Re: Letter Report on Hydrogeological Report  
TES III Contract No. 68-01-7351  
Project No. 05-B87700  
Work Assignment No C03001  
Du Pont Newport Site, Region III

REVIEW/COMMENTS  
ON  
DU PONT NEWPORT SITE

Fence Diagram

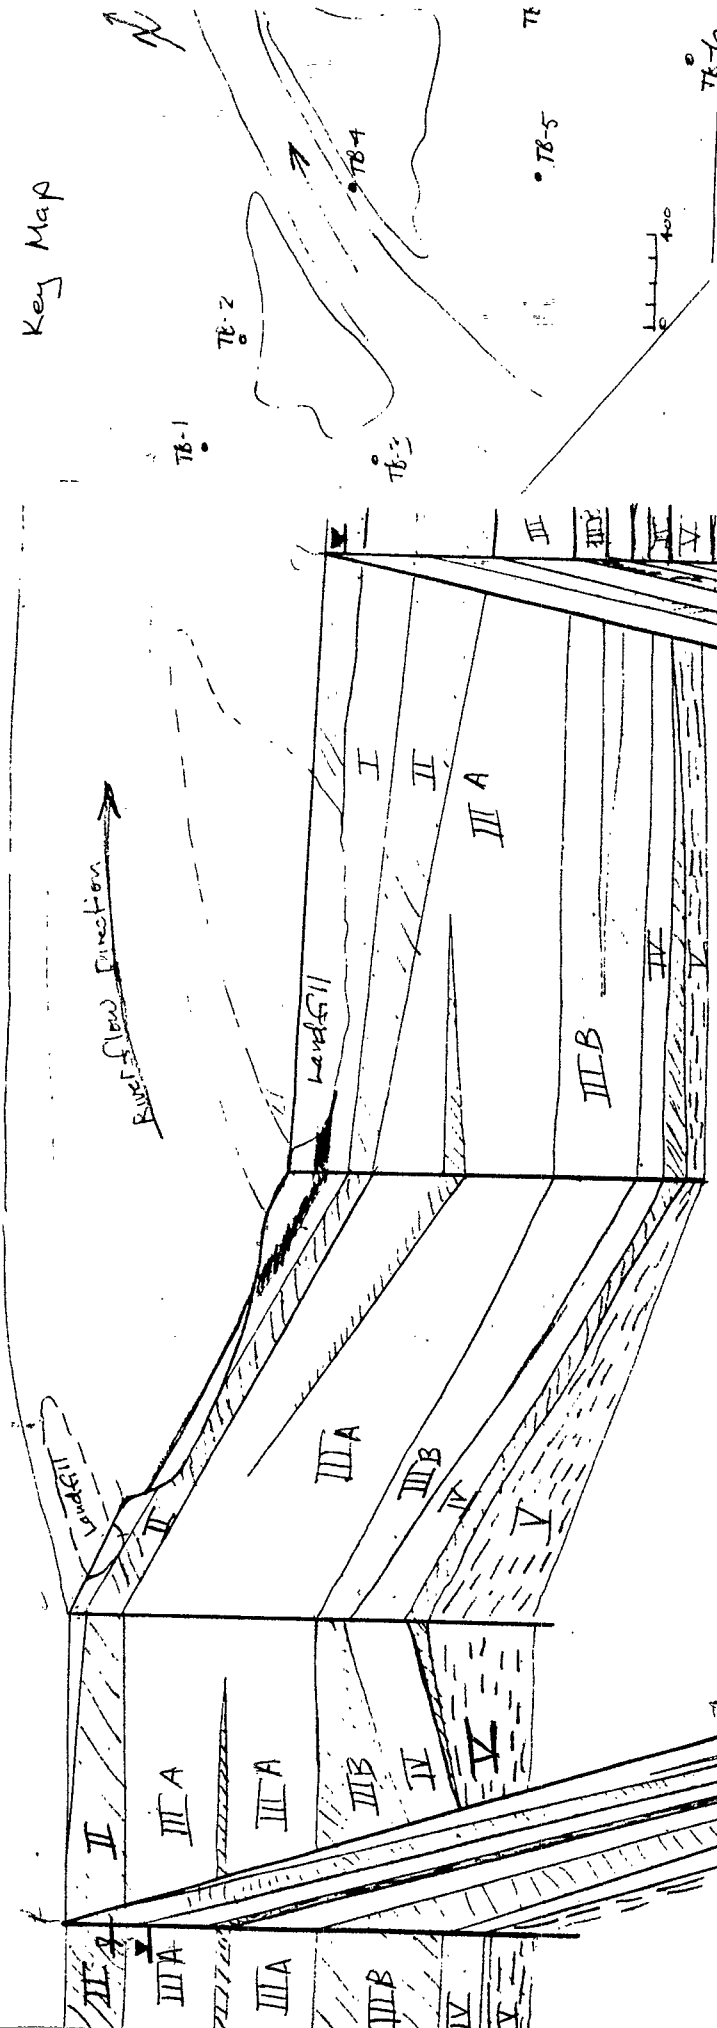
A fence diagram has been drawn to represent the interpretation of data from Volume II. It is recommended that WCC should draw a fence diagram based on the test borings and all other boring log information. WCC should correlate the hydrostratigraphic units from the borehole geophysical logs and test boring data. Additional borings may be needed to define the hydrostratigraphic units. The fence diagram must be drawn to scale and show the river and landfills to scale.

##### Section 3.1

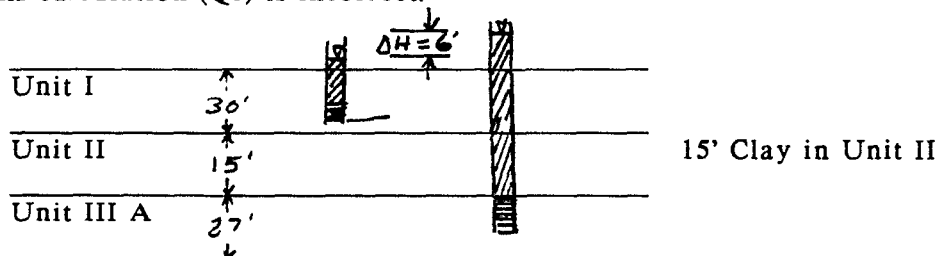
Cross Section A-A was drawn in the approximate dip direction. What is the dip & direction?

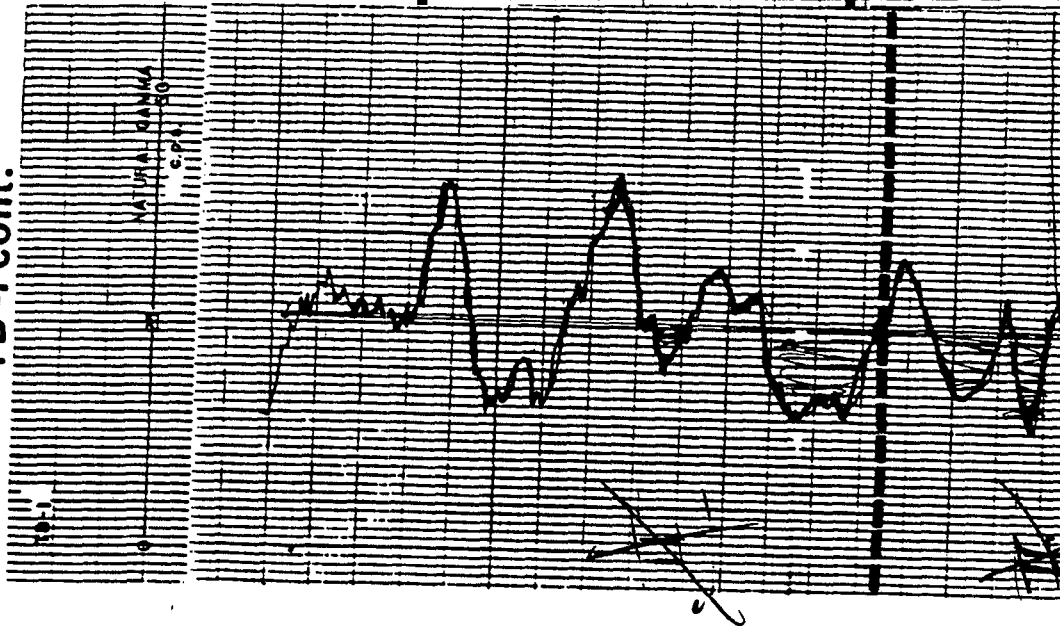
There appears to be (Figures 7 & 8) no near by downgradient wells south of the landfill which length is approximately 1100 feet. It is recommended that Du Pont installs additional shallow monitoring wells (Unit I) wells) completely surround the south landfill. The monitoring should not be spaced from each other at distances no greater than 100 feet. The monitoring well's screen length should be based on the properties of the contaminants which are to be detected. WCC should discuss this point.

The monitoring wells located in Unit III A downgradient from the Newport Plant Landfill and the south landfill appears not to exist (Figures 9 and 10). It is also true that no downgradient wells from both landfills have been placed in Unit IV. Du Pont should propose to EPA a groundwater detection system which monitors Unit III A and Unit IV near both landfill units. It is recommended that a minimum of four (4) monitoring wells in Unit III A and Unit IV be installed between the Newport Landfill and the Christina River. Du Pont should place monitoring wells near the south landfill on its south side and its eastern side in Units III A and IV. The interval between each well should be based on site conditions. Du Pont should explain in their proposal the rationale for choosing the horizontal well spacing and vertical screen location.
